FOSSIL RIDGE SUBDIVISION
 P.O.A.D.P. / P.U.D.

Re: Fossil Ridge (Amending)

POADP # 659-A

REQUEST FOR REVIEW of POADP

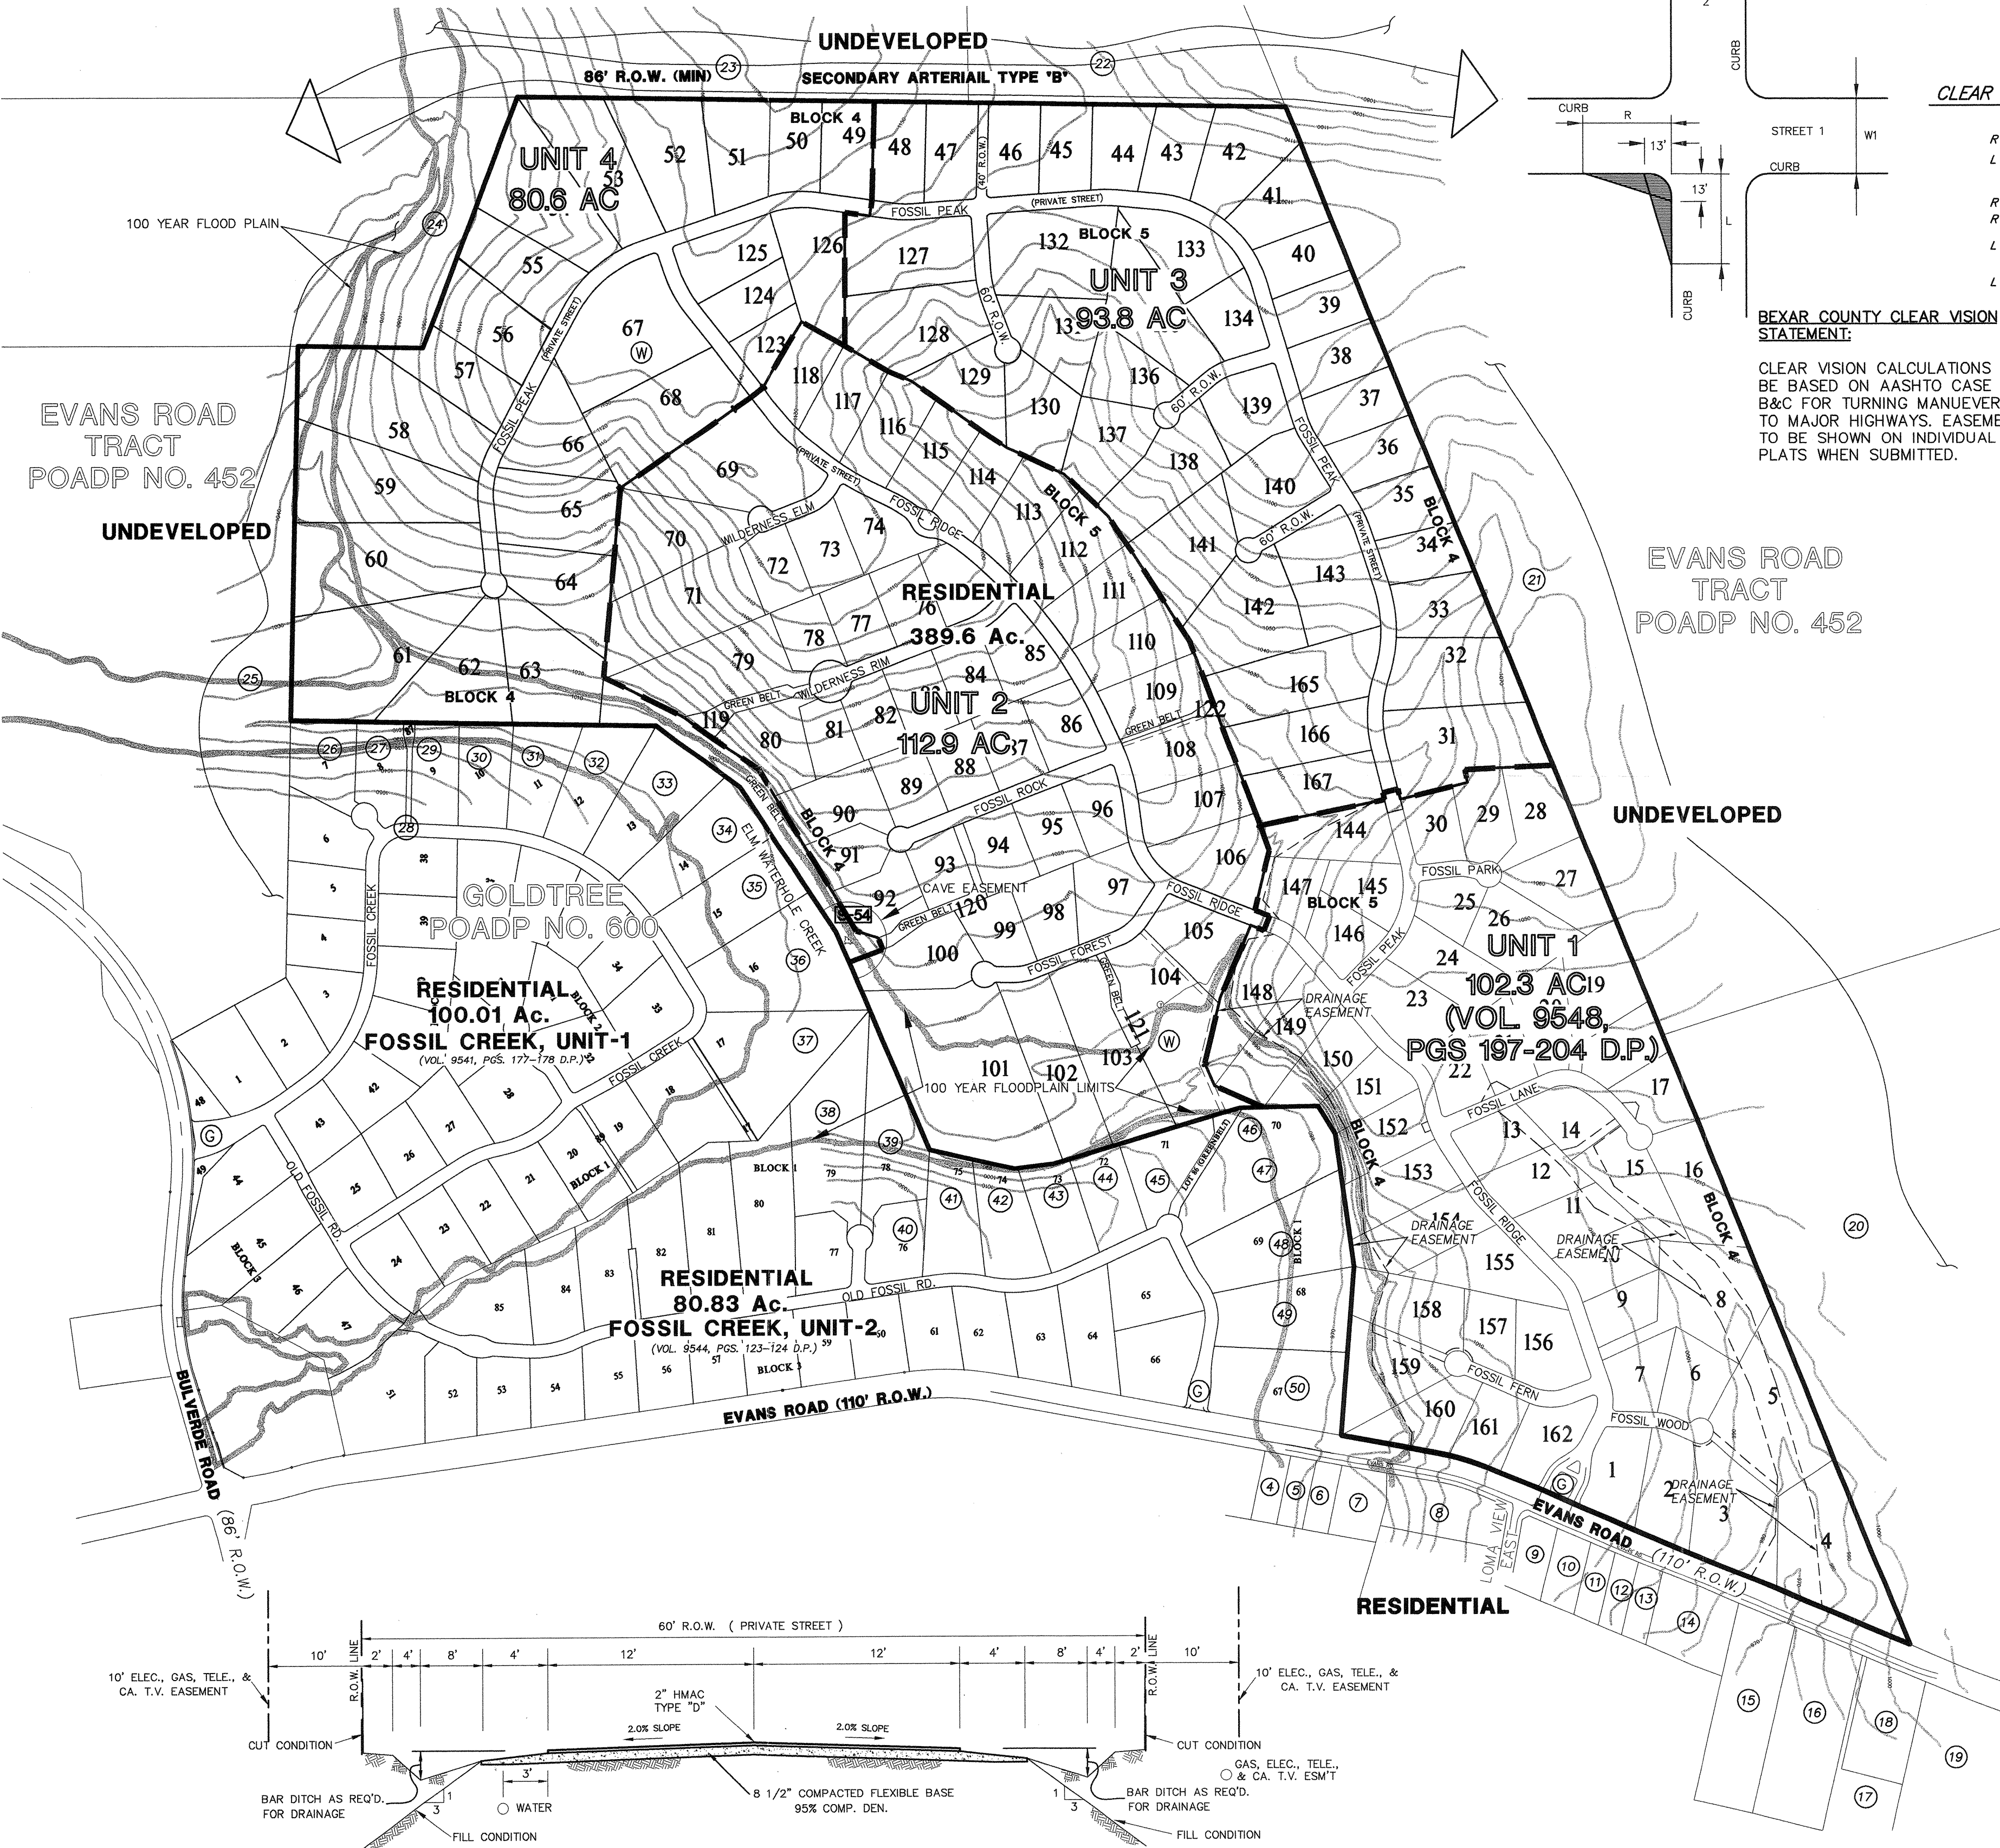
Comments: EVANS ROAD IS ON THE MTP REQUIRING A MIN. OF 110'
ROW - PROPOSE EXTENSION OF STONE OAK PARKWAY IS ON THE MTP AND
TRAVERSE THIS PROPOSE MDP. IN ADDITION, THE SOUTHERN PORTION OF
THIS MDP DOES NOT ADDRESS THE JUDSON THOROUGHFARE REQUIRING
A MIN. OF 80' ROW. HOWEVER, ROADP# 452 DOES DELINEATE THE
PROPOSE EXTENSION OF STONE OAK PARKWAY SLIGHTLY NORTH OF
THIS PROPOSE MDP WITH A CONNECTION TO THE PROPOSE EXTENSION
OF STONE OAK. SEVERAL MEETINGS WITH THE STAKEHOLDERS INVOLVE
HAVE SET THE ALIGNMENT OF STONE OAK EXTENSION NORTH OF
THIS PROPOSE MDP WITH A AMEND REVISING THE CONNECTION OF
THE FUTURE STONE OAK PARKWAY INTERSECTING WITH HWY 281
AND CONTINUING ACROSS TO THE EXISTING STONE OAK PARKWAY
INTERSECTION AT HWY 281. THEREFORE, THE PROPOSE EXTENSION
OF STONE OAK WITH IT AGREED UPON ALIGNMENT, RELEASE
THIS PROPOSE MDP FROM THE STONE OAK PARKWAY THOROUGHFARE
REQUIREMENTS. THIS INCLUDES THE SOUTHERN PORTION OF THIS PROPOSE

MDP WITH REFERENCE TO THE JUDSON THOROUGHFARE.

- Has a flood study been completed to determine BFEs?
- Check sight distance as noted
- Evaluation of cave easement?
- Soil Classification site evaluation
- Letter from water purveyor stating public water availability
- Notation of sensitive recharge features w/ 150' setback radius noted on the plat.

Comments: EVANS ROAD IS ON THE MTP REQUIRING A MIN OF 110'
ROW. PROPOSE EXTENTION OF STONE OAK PARKWAY IS ON THE
MTP AND APPEARS TO BE TRAVERISING THE PROPOSE POADP. PROPOSE
POADP DOES NOT ADDRESS THE PROPOSE EXTENTION OF STONE OAK
PARKWAY. IN ADDITION SOUTH EASTERN PORTION OF POADP DOES NOT ADDRESS THE
JUDSON THOROUGHFARE REQUIRING A MIN OF 86' ROW

GATE ENTRANCE DETAIL

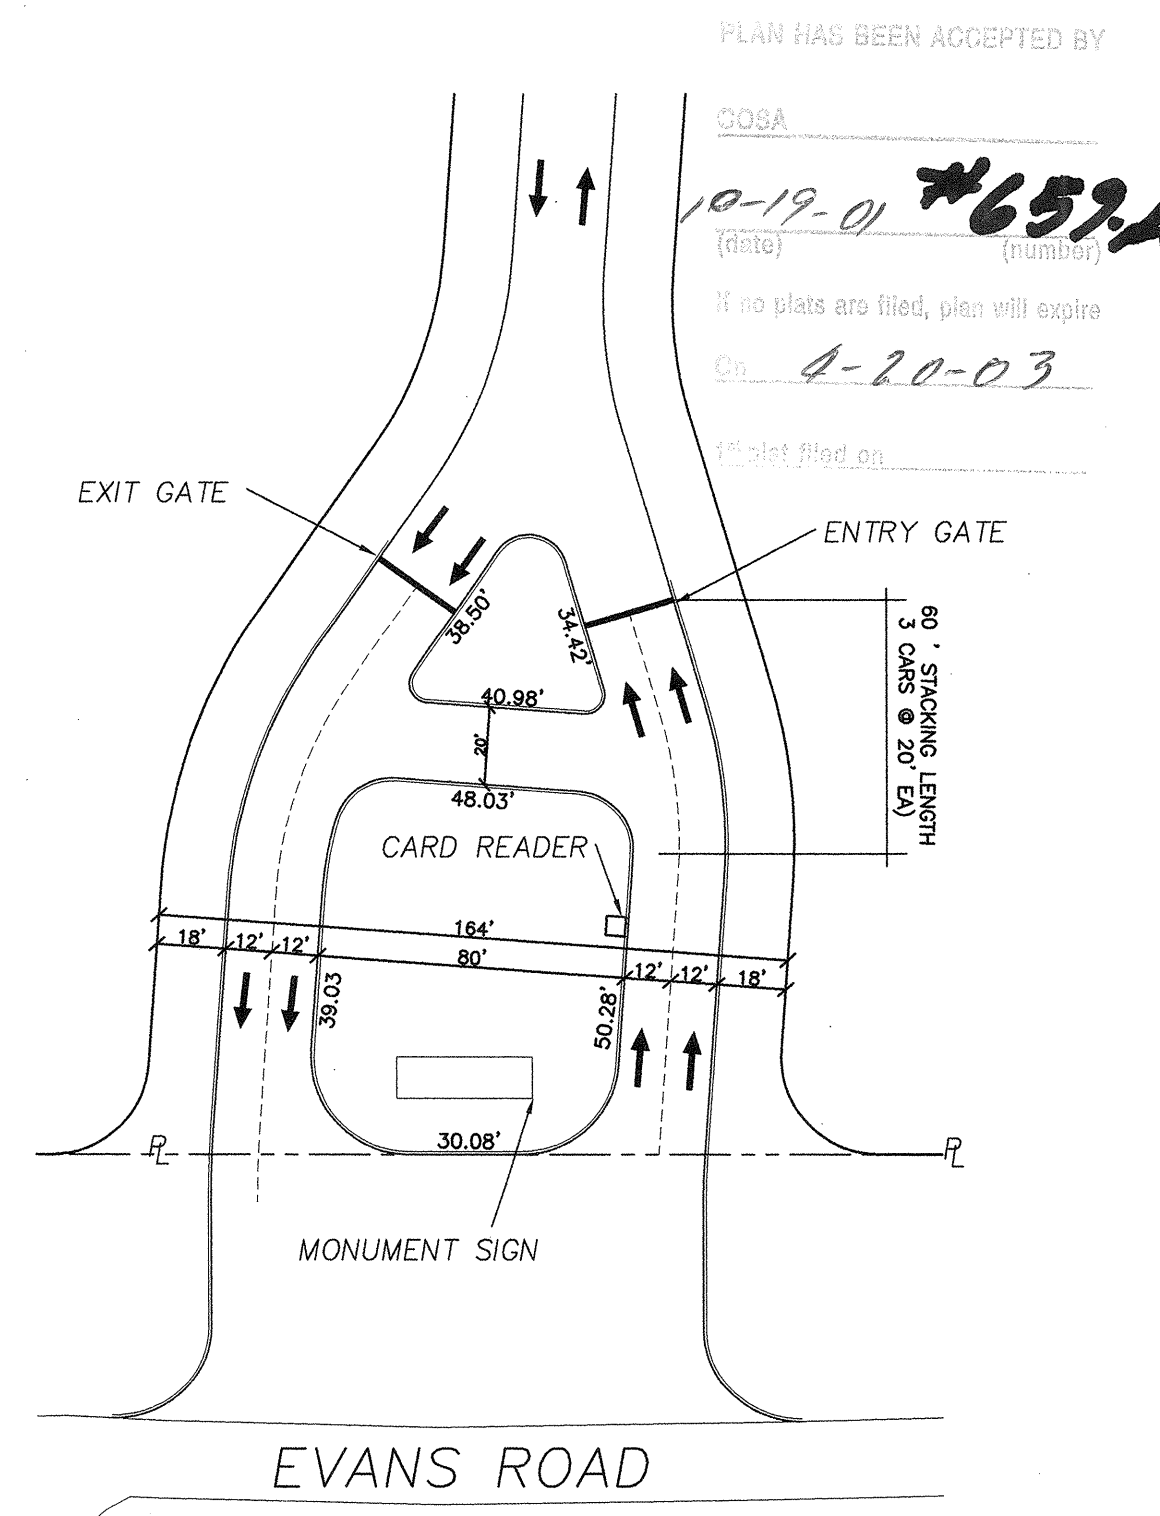
Comments: Cl-desec @ Fossil Peak is too long. Provide dimension for gate detail showing proper stacking.
